North Eastern Regional Power Committee

84th Protection Coordination Sub-Committee Meeting

Date: 09/10/2025 (Thursday)

Venue: Bongaigaon Thermal Power Plant, NTPC

B.6 Grid Disturbance in Ziro, Daporijo, Basar and Along area of Arunachal Pradesh Power System on 13th Aug'25:

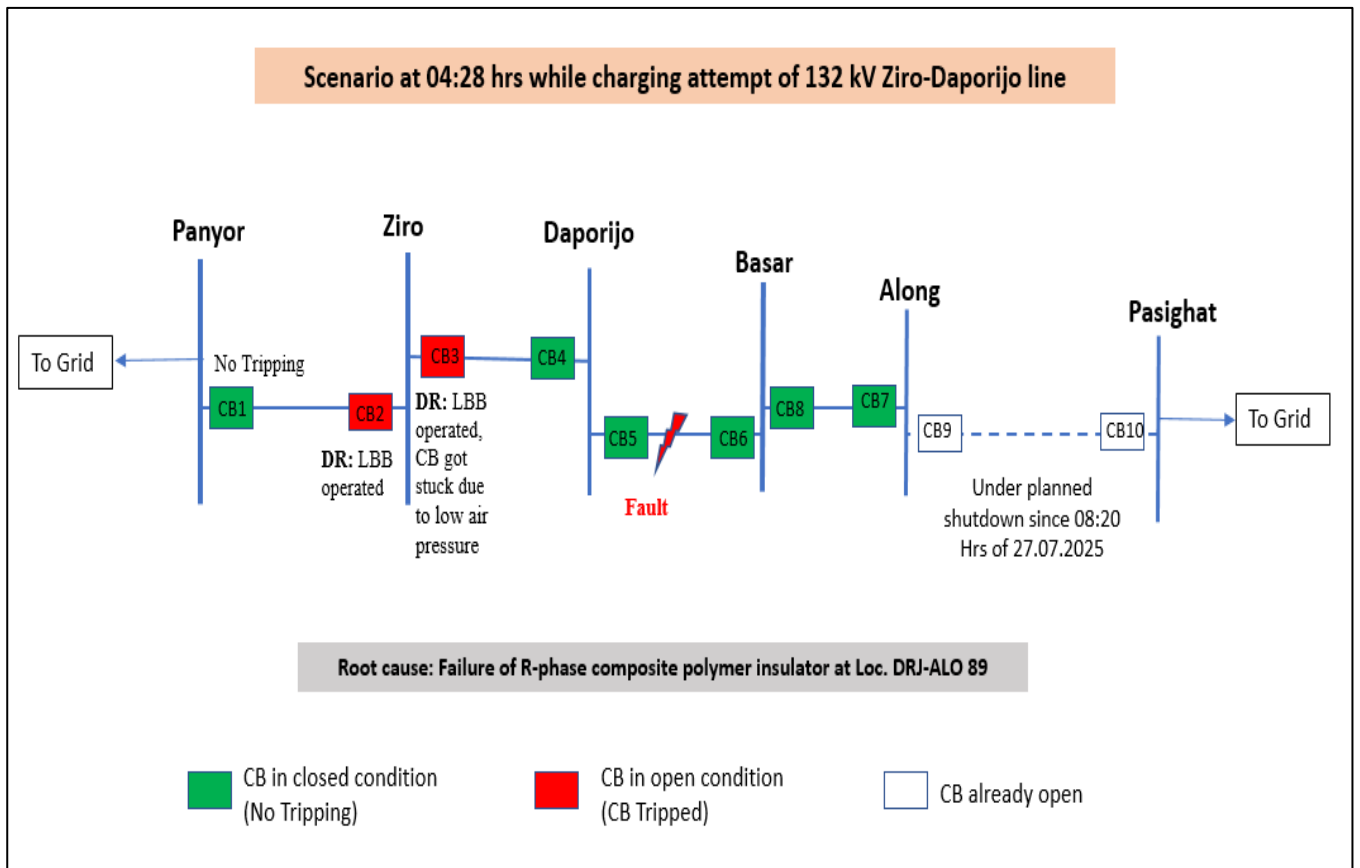
- At 03:31:02.182 hrs, High resistive B-N fault (Ib-189 A, In-146 A, Vb-74 kV) in 132 kV Ziro-Daporijo line cleared on operation of E/F protection from Ziro end. No tripping from Daporjo end (radial)
- While charging attempt of 132 kV Ziro-Daporijo line at 04:24 Hrs, line was charged from Ziro end and at 04:28 hrs during closing of CB at Daporijo end, fault occurred in 132 kV Daporijo-Basar line due to the failure of the R-phase composite polymer insulator at Loc. DRJ-ALO 89.
- Protection system of 132 kV Daporijo-Basar line failed to isolate the fault. CB at Ziro for 132 kV Daporijo line failed to open due to low air pressure, LBB protection operated at Ziro leading to tripping of 132 kV Panyor-Ziro line.

- Share the reason of non-operation of protection system of 132 kV Daporijo-Basar line.

- DR time drift of 2 min observed at Ziro end for 132 kV Daporijo line which needs to be rectified. Availability/healthiness of GPS needs to be ensured and time to be adjusted as per grid code.
- Frequent damage to insulators occurred between Tower Nos. DRJ-ALO 89 and 90 which likely due to area being lightning-prone. Installation of lightning arresters (LA) at this location, along with improvements to the tower earthing, to mitigate future occurrences.

B.7 Grid Disturbance in NEIGRIHMS & IIM areas of Meghalaya Power System on 6th Sept'25:

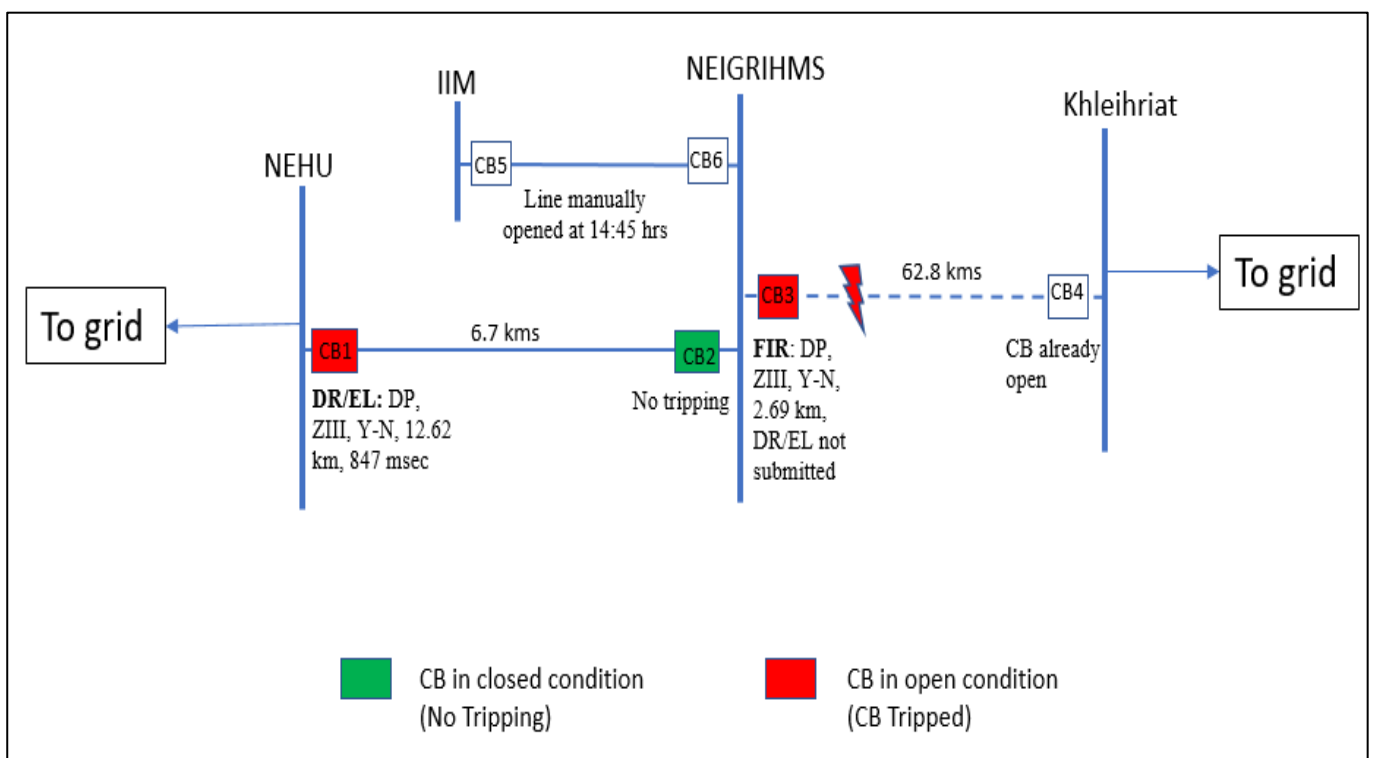
As per DR analysis, at 14:27:26.076 Hrs, R-Y-B fault started in 132 kV NEIGRIHMS-Khleihriat line which was cleared within 582 msec from Khleihriat end on operation of DP, ZII. Fault cleared within 65 msec from NEIGRIHMS end on operation of DP, ZI. Ir-3.9 kA, Iy-4.07 kA, Ib-4.16 kA.

At 14:41 hrs, charging of 132 kV NEIGRIHMS-Khleihriat line was attempted and tripped in DP, ZIII, Y-N, FD: 2.69 Km from NEIGRIHMS end (DR/EL not submitted)

At 14:37:06.334 hrs, Y-N fault initiated and cleared within 847 msec from NEHU end on operation of DP, ZIII. No tripping from NEIGRIHMS end.

Root cause: Conductor snapped at T-Loc 42.

- Review ZII time delay of CB4 and set as per protection philosophy.
- Share the reason why CB3 did not detect the fault in ZI and waited for ZIII time delay despite having fault at a distance of 2.69 km from NEIGRIHMS.
- Tripping of New Umtru Unit-1 seems unwanted. The same needs to be thoroughly investigated.
- Time drift observed: 2 min at Khleihriat end for 132 kV NEIGRIHMS line; 4 min at NEHU for NEIGRIHMS line. Availability/healthiness of GPS needs to be ensured and time to be adjusted as per grid code.

B.8 Grid Disturbance in Rokhia and Mohanpur S/S of Tripura Power system on 18th Sept'25:

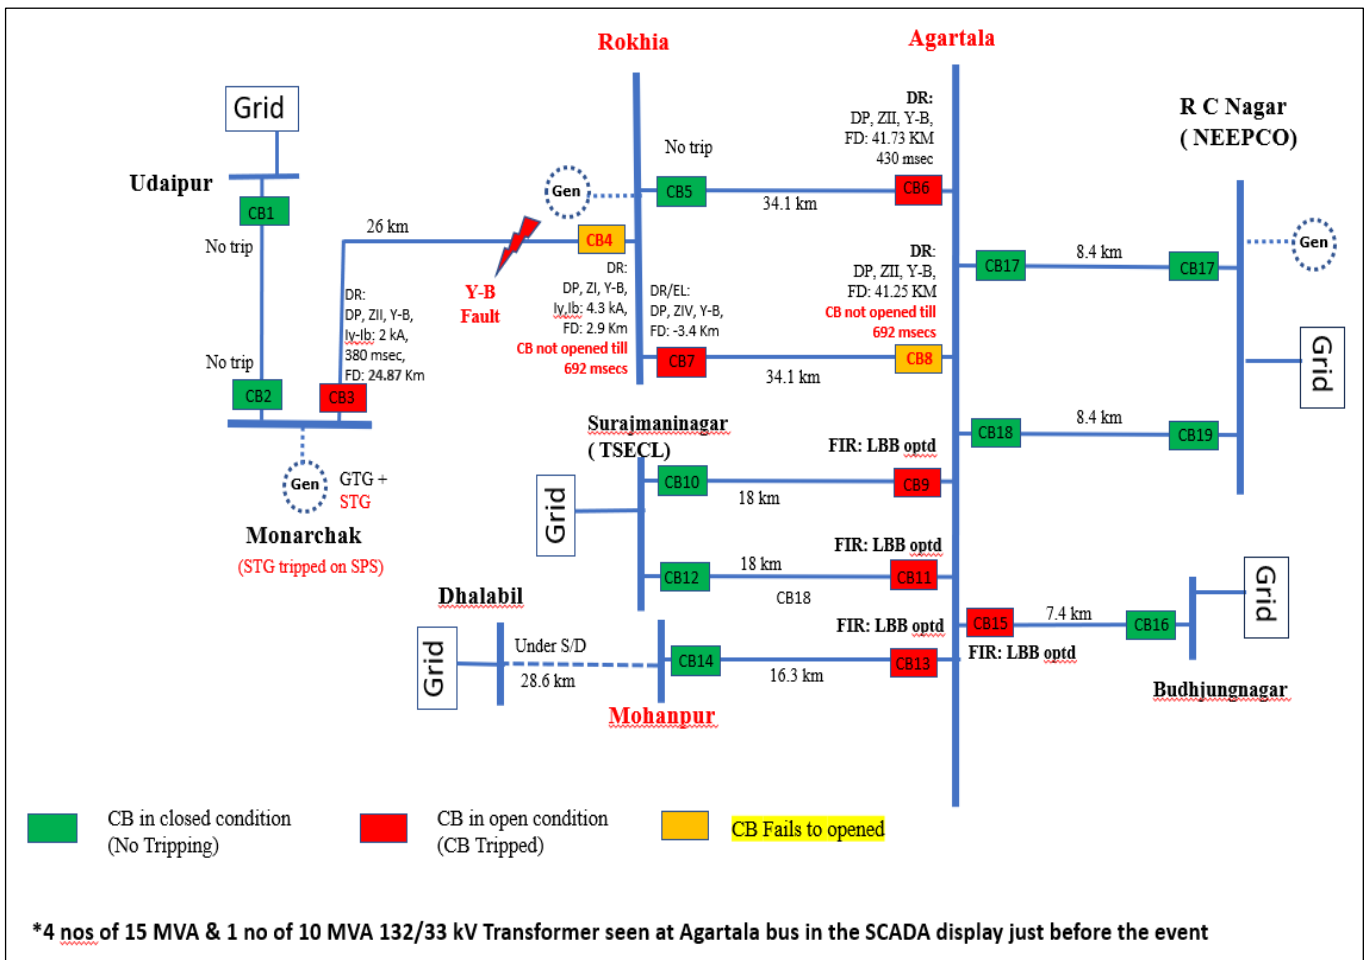
- At 10:35 Hrs, Y-B fault of solid nature appeared in the 132 kV Monarchak – Rokhia line which cleared from Monarchak end correctly. The fault detected at Rokhia end in ZI & issued trip command immediately however the CB fails to opened at Rokhia end resulted into the tripping of 132 kV Rokhia – Agartala 1 after 430 msecs.
- 132 kV Rokhia – Agartala 2-line CB fails to open after trip command issued by the DP relay in ZII. The same line tripped from Rokhia end on operation of Z IV (reverse) in 692 msecs from the initiation of the fault resulted into the GD at Rokhia SS.
- LBB operated at Agartala bus during CB stuck of Rokhia II line caused tripping of 4 lines, however, 132 kV AGTCCPP – Agartala 1 & 2 line not tripped. LBB operation at Agartala SS caused the GD at radially fed Mohanpur area of Tripura.

- Share the reason of non-opening of CB at **Rokhia** for 132 kV Rokhia - Monarchak Line.
- Share the reason of non-opening of CB at **Agartala** for 132 kV Agartala – Rokhia 2 Line.
- LBB healthiness as well as connectivity to all the element connected at Agartala need to be ensured. Actual LBB initiation & operation time not concluded.
- Disturbance Recorder (DR) lack proper recording of CB OPEN & CLOSE status as well as LBB operation in each of the connected element at Agartala and Rokhia which needs to be ensured.
- Status of CB & ISO at Agartala could be collected from the SCADA system during the event. The remedial action should be taken for proper monitoring & event analysis.

B.10 Grid Disturbance in Kolasib, Tuirial & Bairabi HEP of Mizoram Power System on 15th Sept'25:

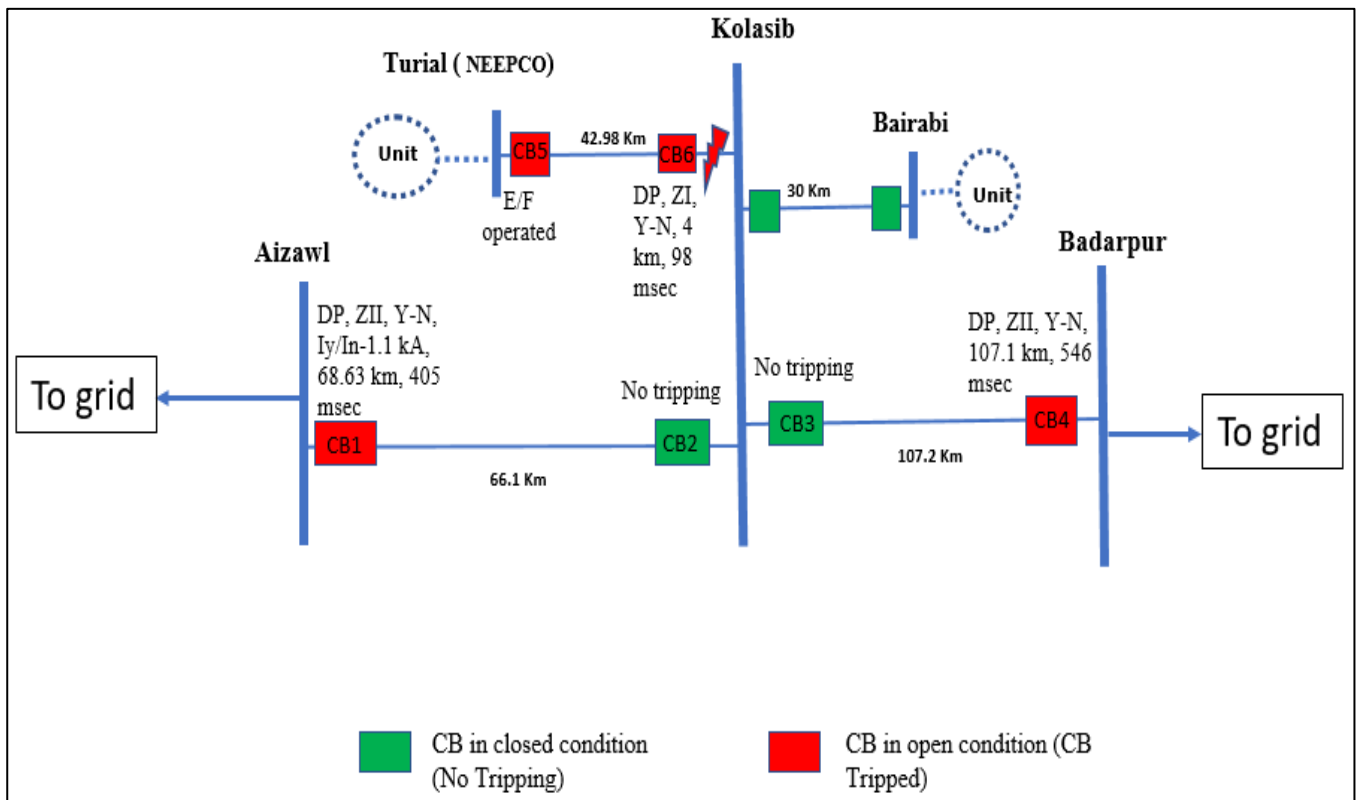
As per DR analysis, Y-N fault (Iy-1.1 kA, In-1.1 kA) initiated at 15:51:25.738 Hrs which was cleared within 405 msec from Aizawl end on operation of DP, ZII and within 546 msec from Badarpur end on operation of DP, ZII. There was no tripping from Kolasib end.

For 132 kV Tuirial - Kolasib line, Y-N fault (Iy-0.83 kA, In-1.2 kA) cleared within 98 msec from Kolasib end on operation of DP, ZI.

At Tuirial end, ZII initiated at 15:51:31.370 hrs for 93 msec. However, any trip signal observed caused likely due to operation of backup E/F.

- Likely High set E/F enabled at Tuirial end of 132 kV Kolasib line which need to be disabled.
- E/F setting needs to be reviewed at Tuirial & Kolasib end along with its directionality.
- P&ED Mizoram to review relay setting of all elements at Kolasib S/S.
- As informed by P&ED Mizoram, in 132 kV Kolasib-Tuirial line, Line CVT not present at Kolasib end which needs to be looked into by P&ED Mizoram.
- Non-submission of Detailed analysis report of the event by P&ED Mizoram which is a violation of Clause 37.2 (e) of IEGC regulation 2023.

C.1 Grid Event at Sanis 30th Aug'25 and 3rd Sep'25:

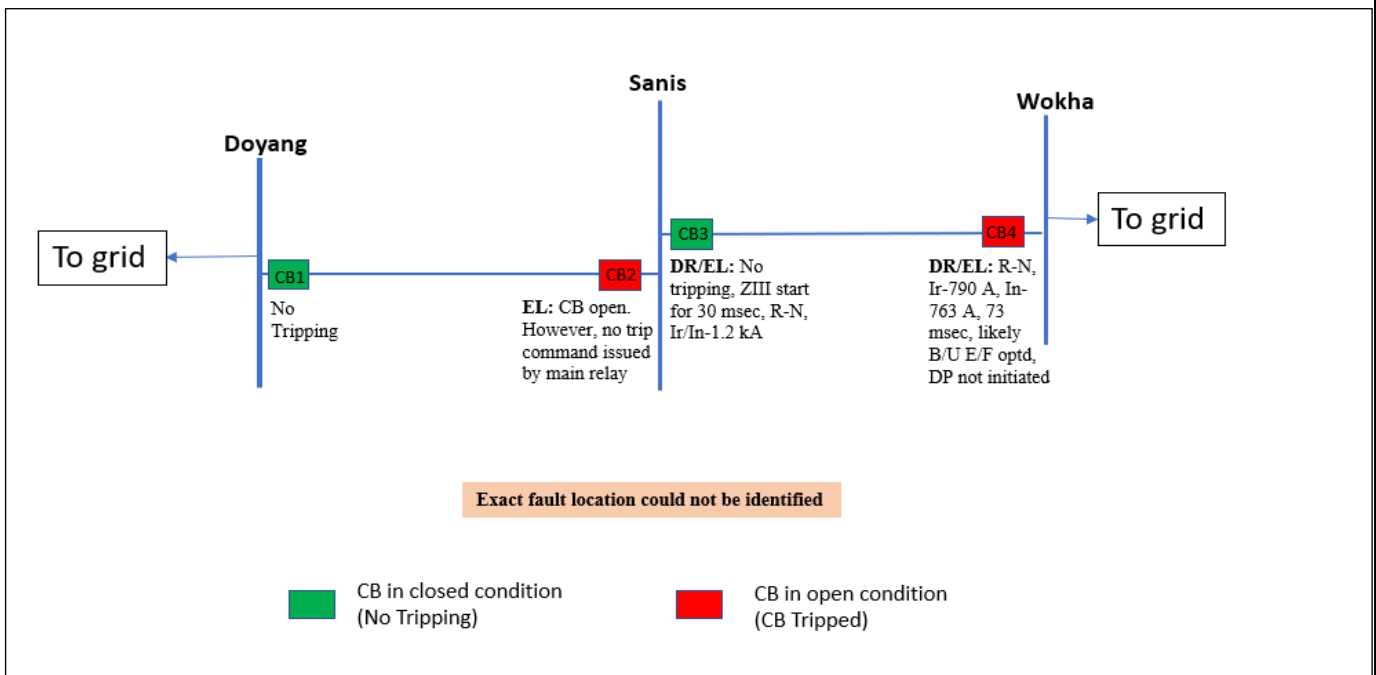
As per DR analysis for Wokha end (Main relay), R-N fault (Ir-790 A, In-763 A) initiated at 12:20:24.888 Hrs which was cleared 73 msecs from Wokha end likely on operation of B/U E/F protection (DR & EL not submitted for backup relay). Also, initiation of backup OC (I_>) & EF (In_>1) protection observed in the main relay. Also, main relay not initiated at Wokha end indicates no fault in the 132 kV Wokha – Sanis line.

From Sanis end (main relay), ZIII initiated for R-N fault (Ir-1280 A, In-1250 A) fault current disappeared within 30 msecs likely after the CB opening at Sanis end of 132 kV Doyang- Sanis line. However, CB was closed as per submitted DR.

At 12:21:24.143 hrs, 132 kV Doyang-Sanis line tripped from Sanis end. As per the submitted EL (main relay) for Sanis end, no tripping command issued by the main protection. [DR&EL for backup relay not shared by DoP, Nagaland.](#)

Exact fault location could not be identified. However, the suspected fault seems beyond the Wokha substation as indicated by the ZIII initiation at Sanis end for 132 kV Sanis – Wokha Line.

- I. Share the exact fault location & root cause for the tripping.
- II. Share the reason for tripping of 132 kV Doyang-Sanis line from Sanis end for fault beyond the line (reverse direction) seems unwanted (newly commissioned on 20th Aug 2025).
- III. Share the reason for tripping of 132 kV Wokha-Sanis line from Wokha end for fault beyond the line (reverse direction) in 73 msec seems unwanted.
- IV. Healthiness of the backup relay need to be tested at Sanis & Wokha.
- V. DR downloading facility need to be implemented at Siemens relay at Sanis & Avana make relay at Wokha (otherwise relay replacement to be done).

In 83rd PCCM, Forum requested DoP Nagaland to take above action points and rectify the directionality issue for CB2 by checking the CT polarity.

C.2 Tripping of multiple elements at 220 kV Agia substation of Assam on 14-08-2025:

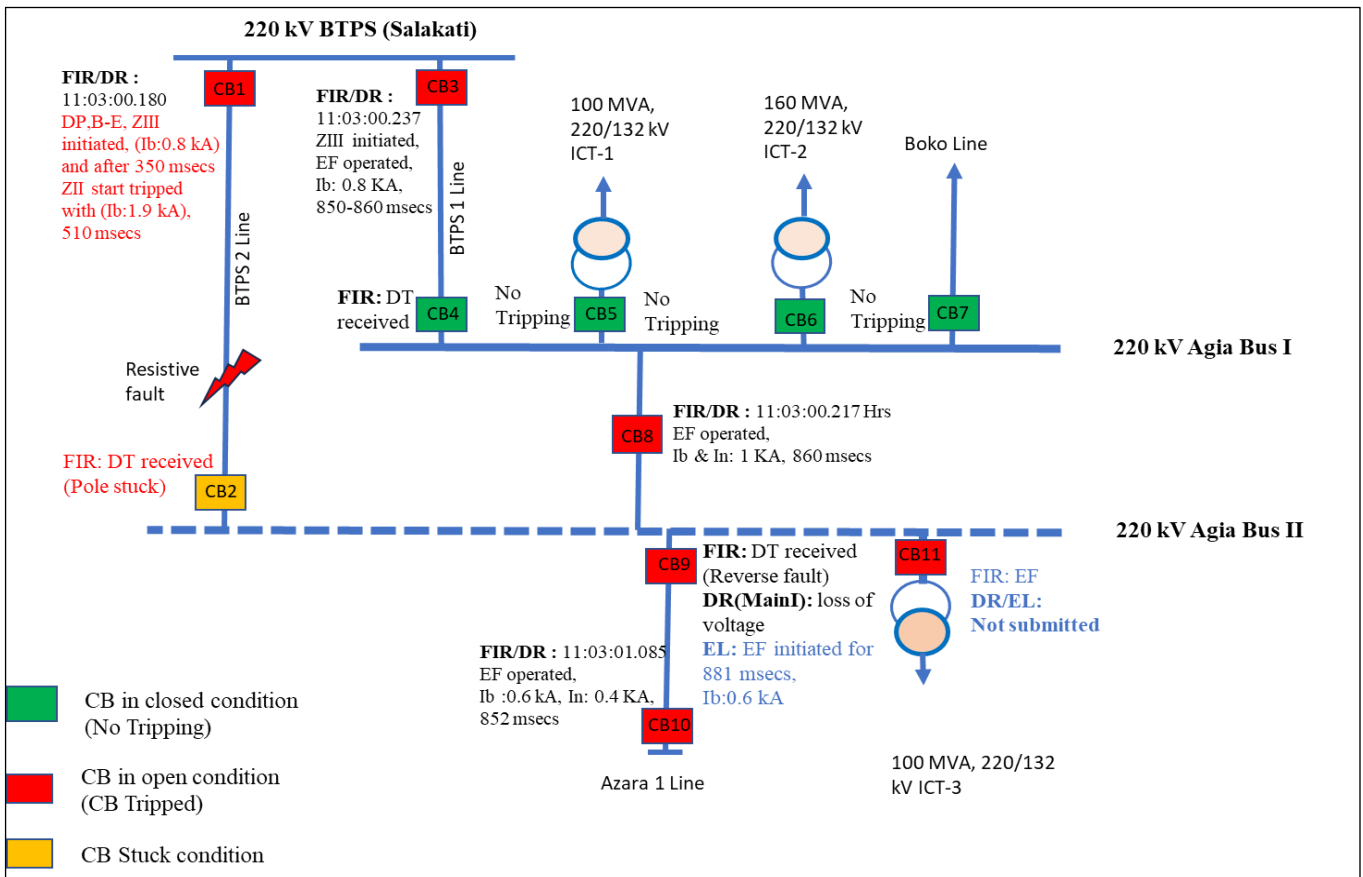
High resistive fault observed in the 220 kV Agia – BTPS II line, cleared from BTPS end by the DP, ZII protection within 510 msecs. Also send DT signal to Agia end. However, the CB got stuck at Agia for the same line.

LBB relay not initiated during the fault at Agia Bus II.

The fault was cleared from the system by tripping of 220 kV Agia – BTPS I line, Bus Coupler & 220 kV Agia–Azara Line in 850-860 msecs.

Also, the fault persisted in the system for 1670 msecs and finally cleared by tripping of ICT-3 which causes the blackout of Bus II at Agia SS.

1. Share the reason for non-operation of LBB relay for Agia Bus II.
2. Share the reason for EF pickup at Agia end for 220 kV Agia - Azara Line & ICT-3.
3. Share the reason for DT sent (as informed verbally) from BTPS end for ZII tripping.
4. DT received & DT sent need to incorporated at in the DR for each element.

AEGCL informed that DT was sent from the BTPC end as per the philosophy set by the OEM. Further he informed that the pole issue has been resolved.

1. Rectify the directionality issues of CB11 and CB9
2. Rectify the LBB issues for Agia Bus II
3. Set the DT sending philosophy only as per the NERPC protection protocol.
4. Coordinate the timing of the EF protection of the Bus coupler at Agia with the ZII of the CB3.
5. DT received & DT sent need to be incorporated in the DR for each element.

C.3 Grid event at multiple areas of the Manipur on 5th Sep'25:

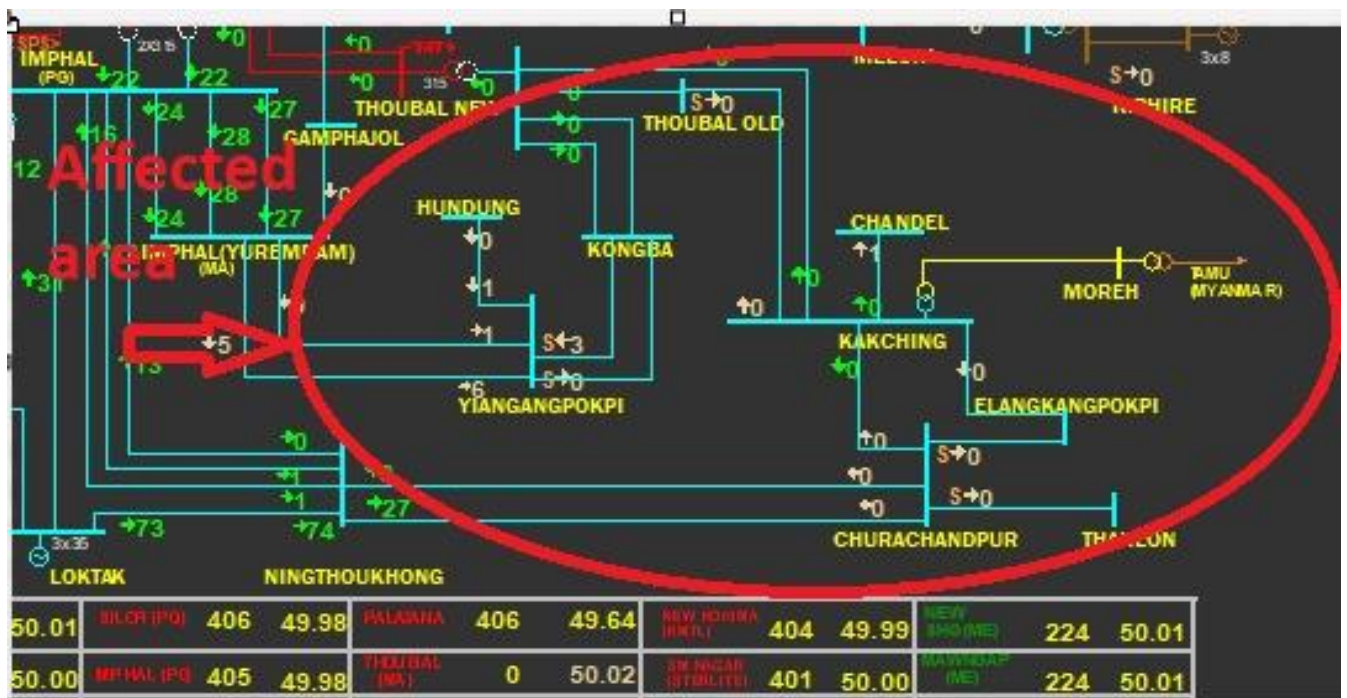
Multiple areas of Manipur were feeding through Imphal & Ningthoukhong substation with 132 kV Ningthoukhong-Churachandpur 2 line and 132 kV Imphal-Yiangangpokpi I line only.

The exact sequence of event could not be identified due to lack to numerical relay for backup protection at Ningthoukhong.

- I. Requirement of the testing of the static relay at Ningthoukhong to check the healthiness (as per setting relay should not have operated due such loading). Also, static relays to be replaced with numerical type as early as possible.
- II. Backup setting need to be incorporated in the main to cross verify the performance of the backup OC, EF relay (static relay) at Ningthoukhong.

- III. Overloading setting need to be revised for 132 kV Imphal – Yiangangpokpi 1 line (currently pickup current: 300 A only).
- IV. Time drift of 1 hr observed in the DR of Yurembam (Imphal). The same need to be matched.
- V. Time synchronizer need to installed at Imphal & Ningthoukhong as early as possible.

1. Revised the O/C pickup current setting at Yurembam for the Yiangangpokpi line to 450 Amps.
2. Replace all the static and electromagnetic relays with the numeric relay in their system
3. Put the B/U protection settings in the Main relay at Ningthoukhong for the Churachandpur line.
4. Perform testing of the static relay at Ningthoukhong to check the healthiness (as per setting relay should not have operated due such loading).
5. Time synchronizer need to installed at Imphal & Ningthoukhong as early as possible.
